**ITEM 16 PROPOSED EXTENSIONS TO LAKESIDE SHOPPING CENTRE
FRONTING GRAND BOULEVARD AND BOAS AVENUE ON
PART OF LOT 504 JOONDALUP DRIVE – [08431]**

PURPOSE

To request Council's determination of an Application for Planning Approval for extensions to the Lakeside Shopping Centre in the Joondalup Central Business District (CBD).

Figure 11 Access Arrangements to the Upper Deck Car Park off Grand Boulevard

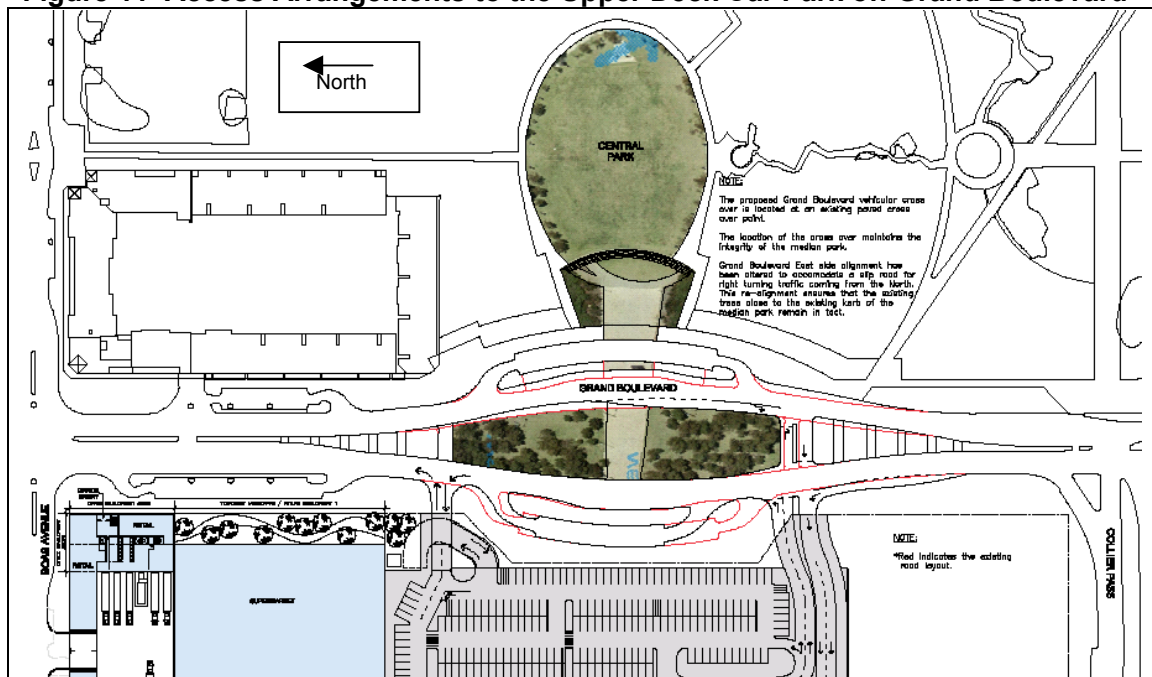
Figure 11 indicates that the access points off Grand Boulevard would require modifications to Grand Boulevard. The proposed changes would involve:

- The main entrance to the upper deck car park on Grand Boulevard was located to cut through the southern stand of trees in the landscaped median at a position that does not align with the axis of Central Park to Grand Boulevard (as can be envisaged with reference to Figure 14). The impact to the aesthetics of Grand Boulevard would have been severe. The City requested that alternatives be investigated.

Figure 12. Access Arrangements off Collier Pass

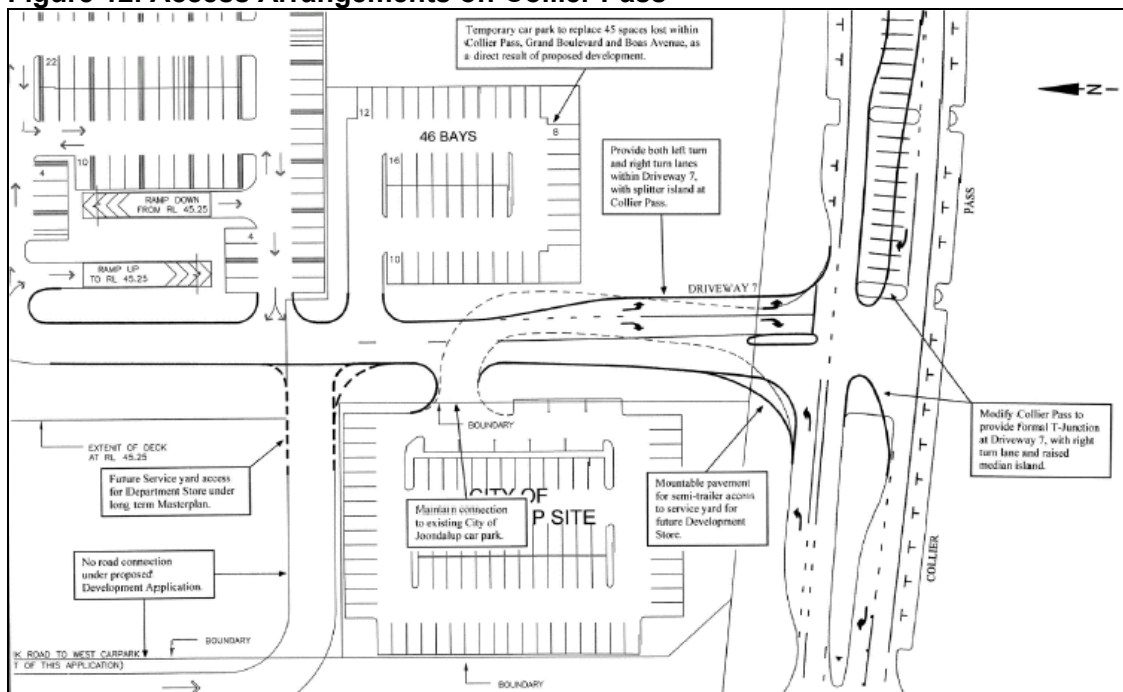
- (iv) A 'road safety audit' should be required to form part of the detailed design process at building approval stage.
- (c) Should it be required, the replacement 46 bay car park indicated on Figure 12 should be subject to a legal agreement, at the applicant's cost, to protect the City rights in regard to the provision and operation of replacement parking.
